TECHNICAL SERVICE BULLETIN
T09 - 02

To: All RedMax Distributors and Dealers
Subject: GZ3500T Carburetor

PRODUCT MODEL	SERIAL NUMBER
GZ3500T	Serial Number 8XXXXXXX

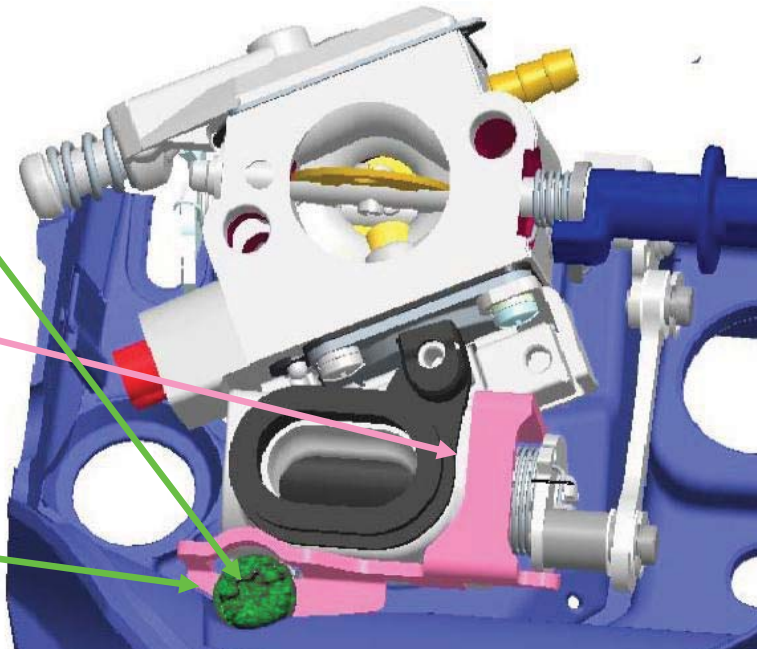
Problem:The Air Valve could become misaligned at idle preventing advancement of the throttle.

1. Remove the Air Box Cover, and Air Filter
2. Remove Screw from Carburetor
3. Lay Bracket into place as shown

Solution: Install alignment bracket on the air valve. This bracket will keep the Air Valve linkage aligned with the Throttle Valve linkage when the Throttle lever is depressed.

4. Reinstall screw and tighten securely
5. Reinstall the Air Box Cover, and Air Filter
